14MP
14 Milton Place
Gravesend
DA12 2BT
Kent

Interior refurbishment
Listed Building Consent 20250269

Details showing how the insulation boards will be installed in relation to the skirting boards and architraves.
Sash windows with architrave:
-Bedroom 1, 2, 3, 4
-Kitchen
-Reception room

14MP10/PR **Rev.3**

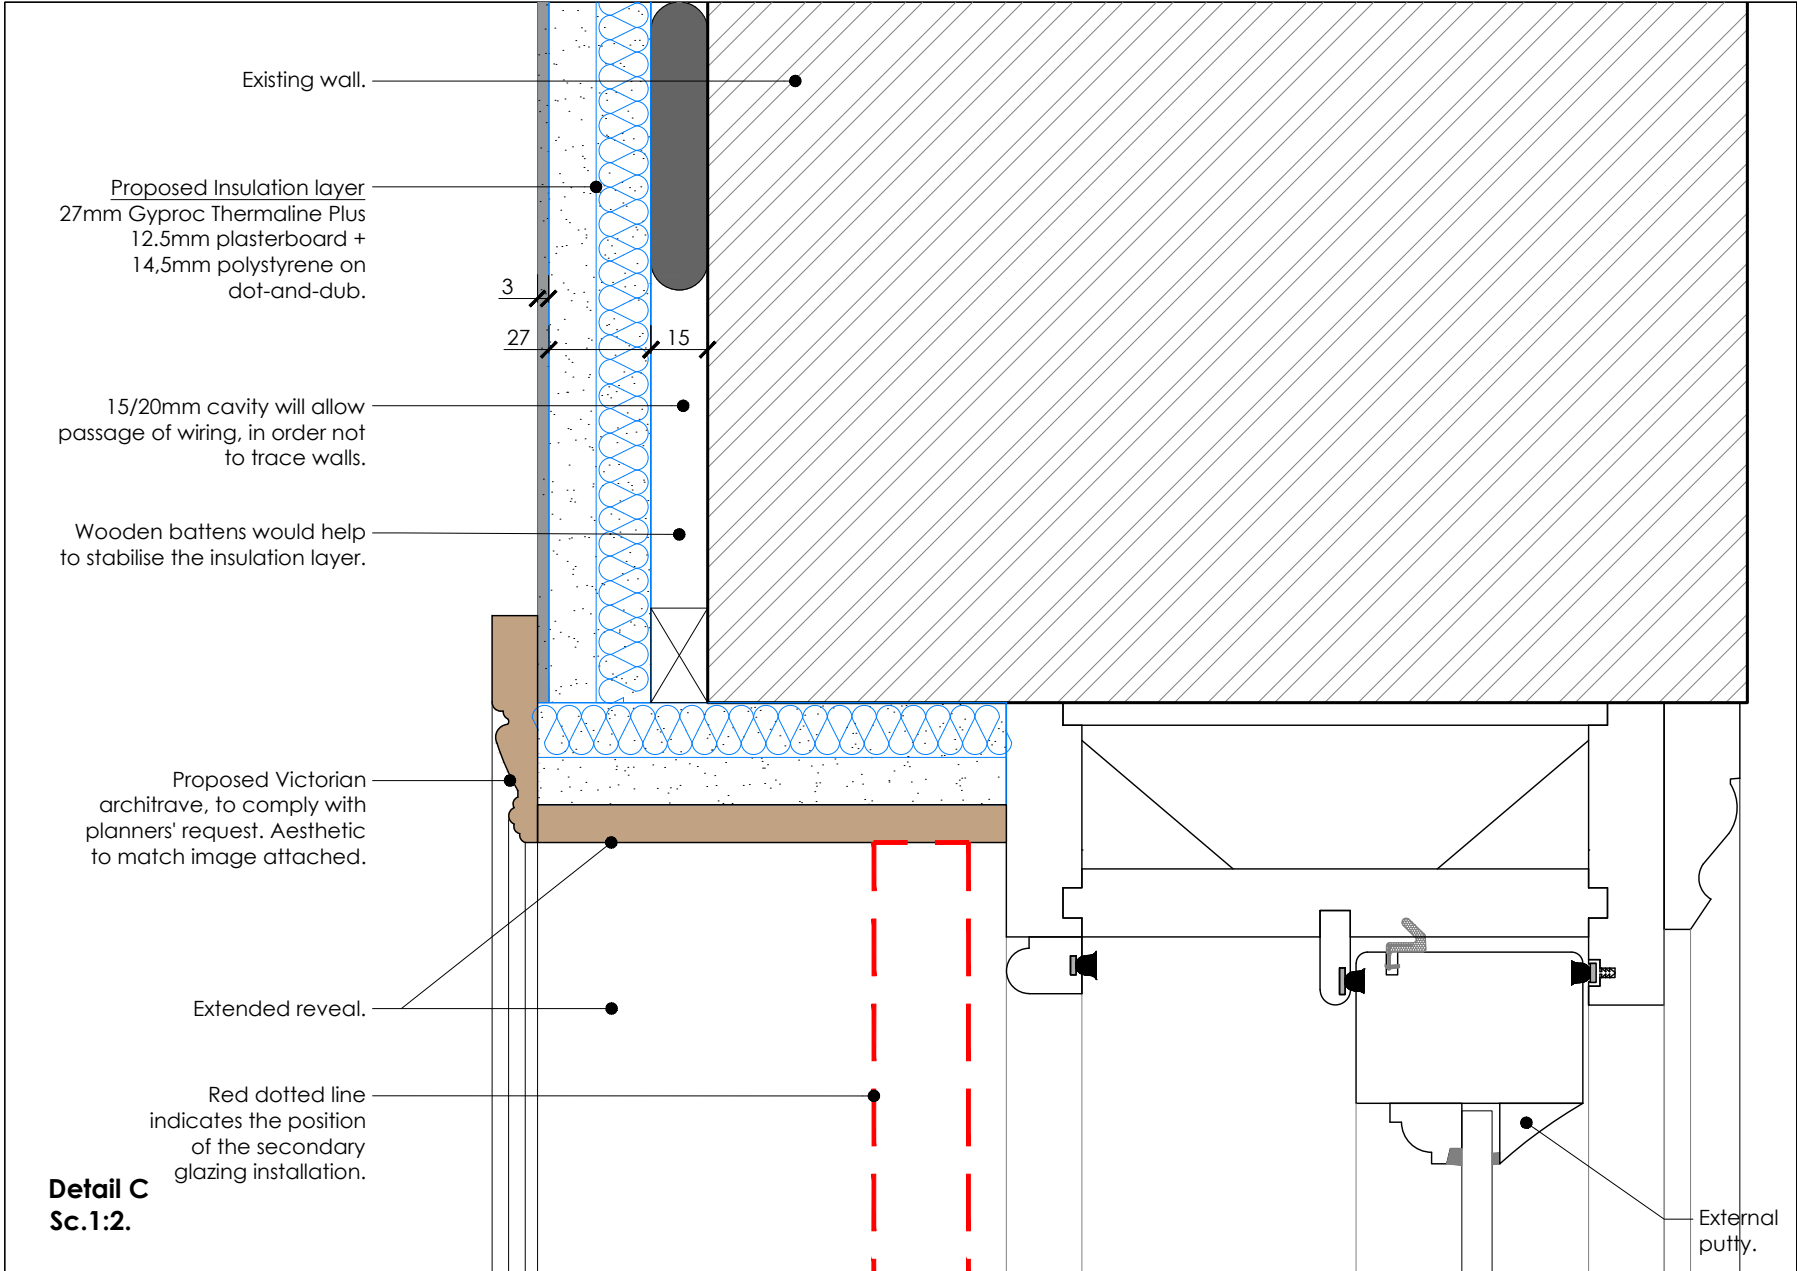
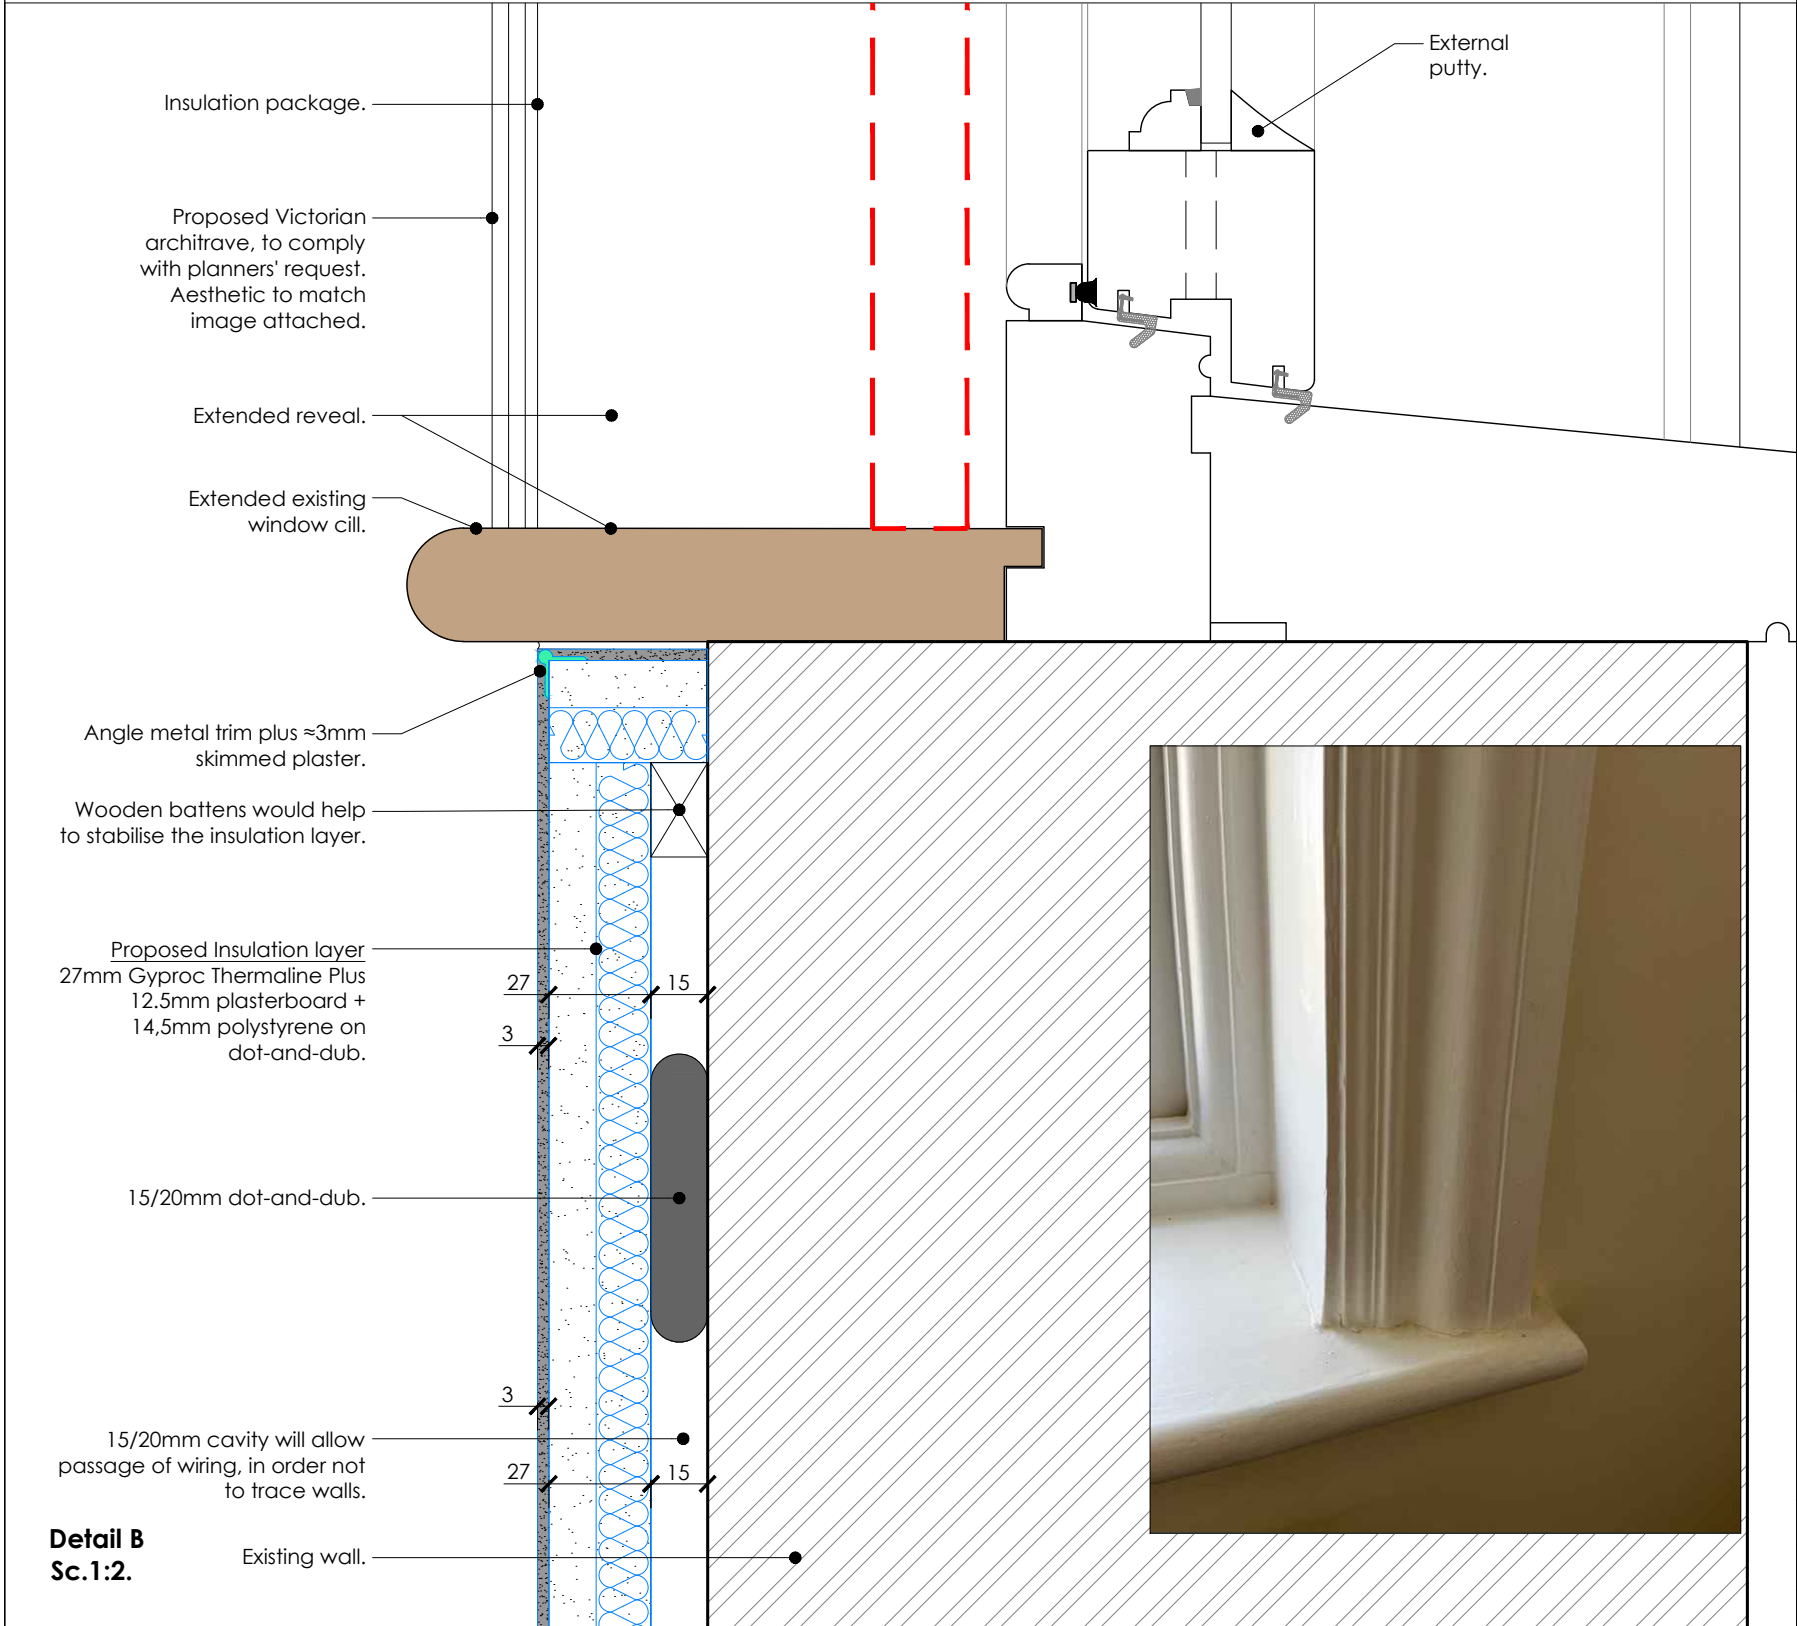
-Window's reveals adjusted by extending the window cill and reveal board with an Victorian architrave.
-Proposed new Victorian skirting board , as per planners' suggestion.

-Windows architraves' setting amended as per planners' request.
Architrave to be added also to Bedroom 2, 4 and Reception room.

-Windows details amended to reflect existing section.
-Secondary glazing details and notes for reference.
